寄件者: AI TSANG <[REDACTED]>
寄件日期: 2026年04月15日星期三 12:35
收件者: Cheryl Tsz Man TSANG/PLAND
主旨: Re: Planning Application No. A/NE-MKT/60 Temporary Open Storage of Metal Scaffolding with Ancillary Office for a Period of 3 Years
附件: response to TD comment.pdf; Traffic impact proposal.pdf; run in _out design proposal.pdf; swept path plan 1.pdf

A/NE-MKT/60

Run in / out Design Proposal

Project Name: Proposed Temporary Open Storage of metal scaffolding with Ancillary Office for a period of three years

Layout Plan		
January 2026	Lot,751 S.B RP in D.D.82	YING SHING (HOPEWELL) ENGINEERING CO.LTD.
1:1000		Annex 1

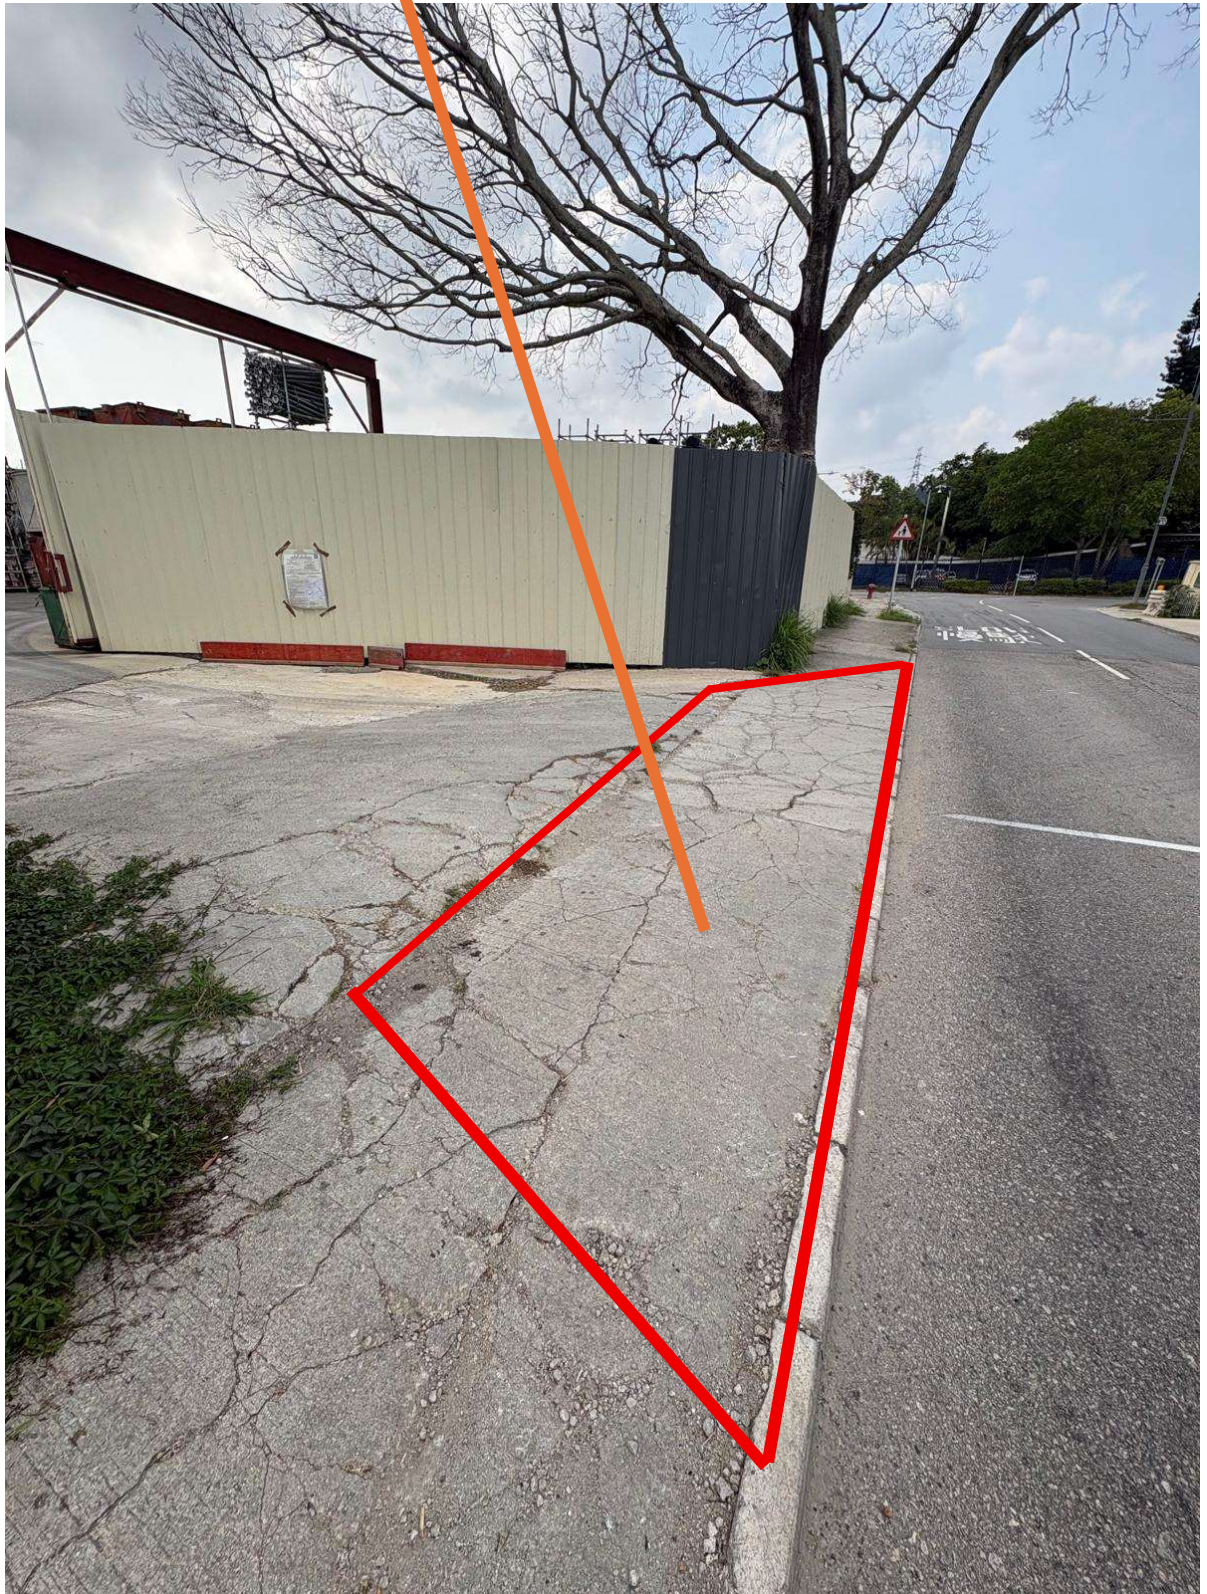
Comment 2
The applicant shall provide a proposal on the vehicular access arrangement including the run-in/out design for the vehicles leaving/entering the applied use;
Response
Noted. Please refer to run-in/out design proposal.

Proposed Run in/out

January 2026	Swept path Plan Lot,751 S.B RP in D.D.82	YING SHING (HOPEWELL) ENGINEERING CO.LTD.
1:1000		Annex 2

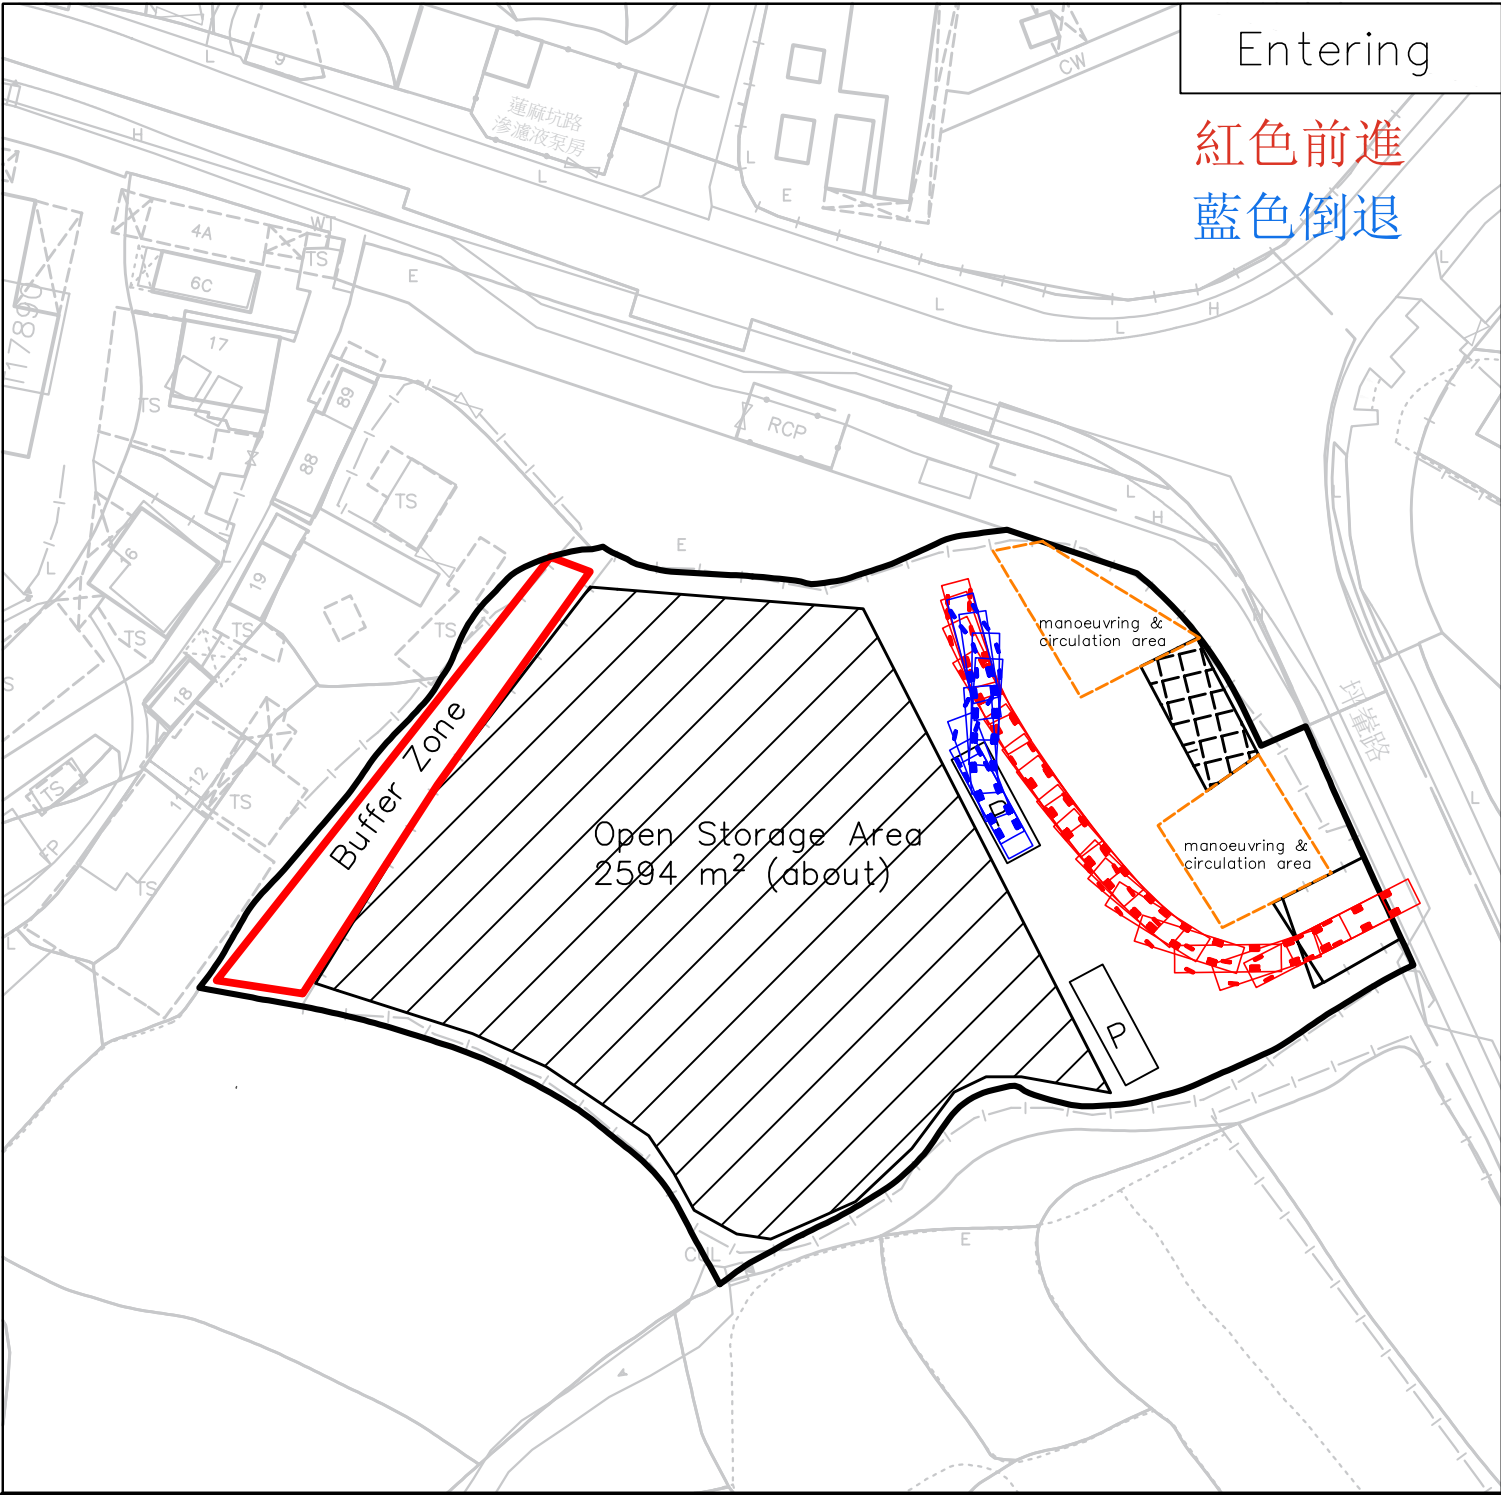
Comment 1
The applicant should justify the adequacy of the proposed 6m width of the ingress and egress for vehicular access;
Response
The applicant confirms that the proposed 6 m wide ingress and egress provides sufficient width for vehicles to enter and exit the site with comfortable and smooth maneuvering angles. In addition, the applicant confirms that the number of ingress and egress points is sufficient to meet the requirements of daily operations, given the very low frequency of vehicle movements Please refer to swept path plans.

Comment 3
The applicant shall demonstrate the satisfactory manoeuvring of goods vehicles entering and exiting the application site (the Site), manoeuvring within the Site and into/out of the parking spaces, preferably using the swept path analysis;
Response
Noted. Please refer to Swept path plans.
